# Duquesne Light

May 16, 1986

Reference: Beaver Valley Power Station, Unit No. 1  
Docket No. 50-334, License NO. DPR-66  
Reactor Vessel Neutron Fluence Additional Information

Figure II.2-3. Maximum Fast Neutron ( $E > 1.0$  MeV) Fluence at the Pressure Vessel Inner Radius as a Function of Azimuthal Angle

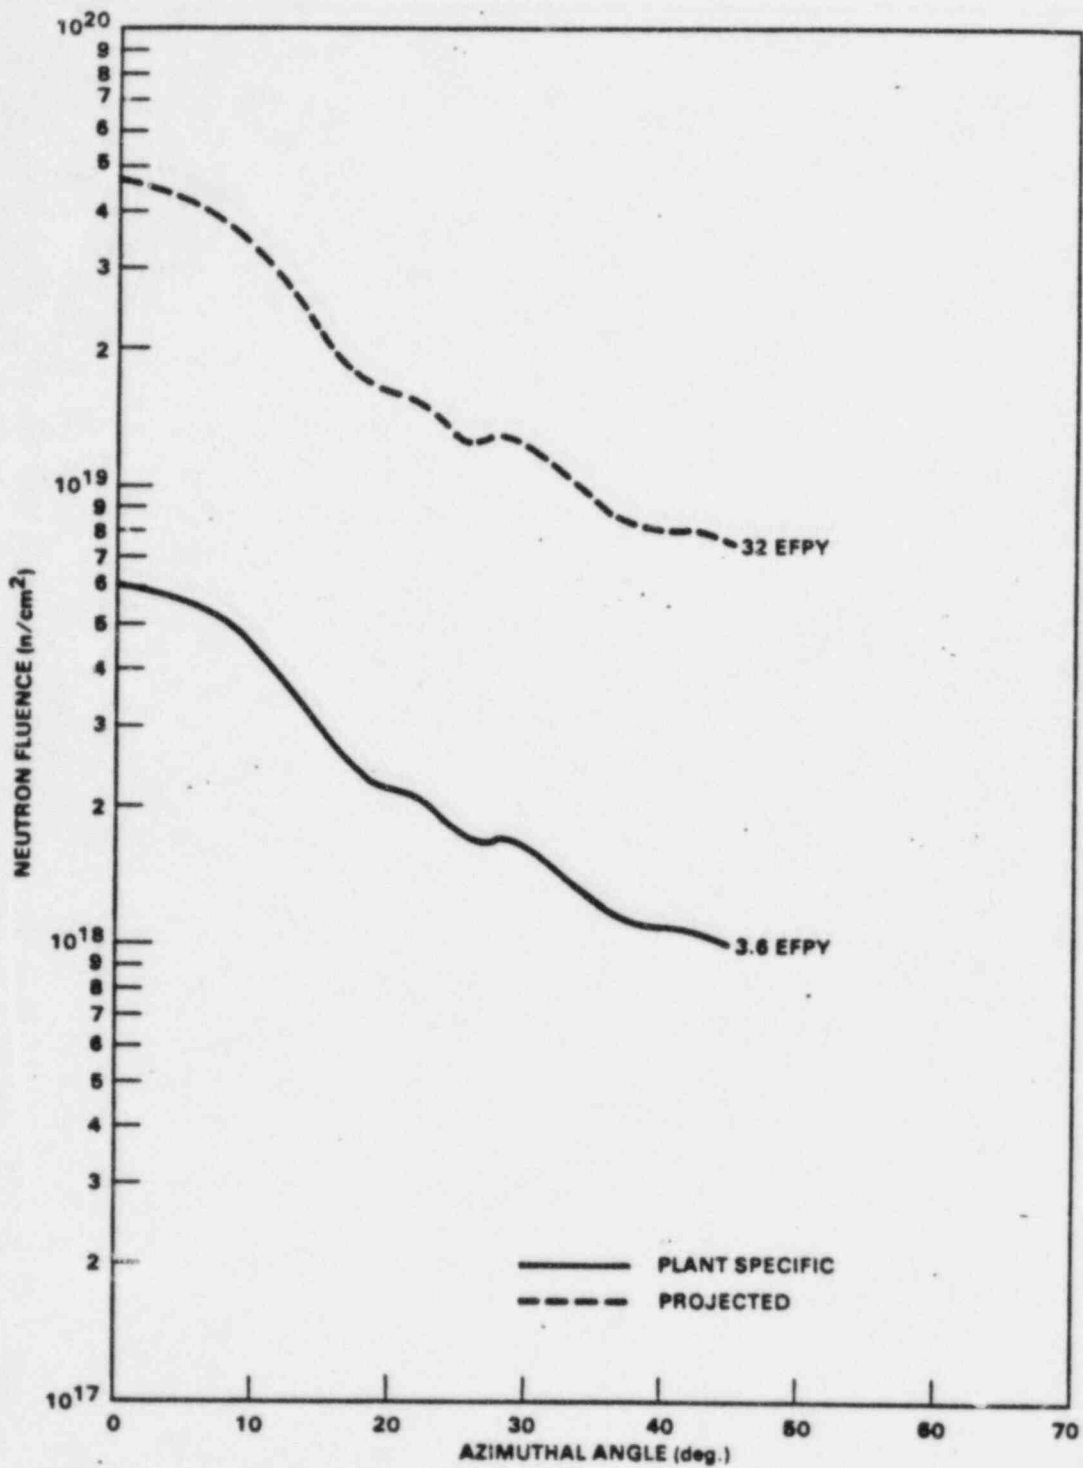
2. Request - Give the azimuthal distribution of the ( $E \geq 1.0\text{MeV}$ ) neutron fluence to the inner surface of the pressure vessel, present and at the end of life.

Response: Section II.2: Fast Neutron Fluence Results, Figure II.2-3: Maximum Fast Neutron ( $E > 1\text{MeV}$ ) Fluence at the Pressure Vessel Inner Radius as a Function of Azimuthal Angle.

The azimuthal variation of maximum fast neutron ( $E > 1.0$  MeV) fluence at the inner radius of the pressure vessel is presented in Figure II.2-3 as a function of azimuthal angle. Data are presented for both current and projected end-of-life conditions. In Figure II.2-4, the relative radial variation of fast neutron flux and fluence within the pressure vessel wall is presented. Similar data showing the relative axial variation of fast neutron flux and fluence over the beltline region of the pressure vessel is shown in Figure II.2-5. A three-dimensional description of the fast neutron exposure of the pressure vessel wall can be constructed using the data given in Figures II.2-3 through II.2-5 along with the relation
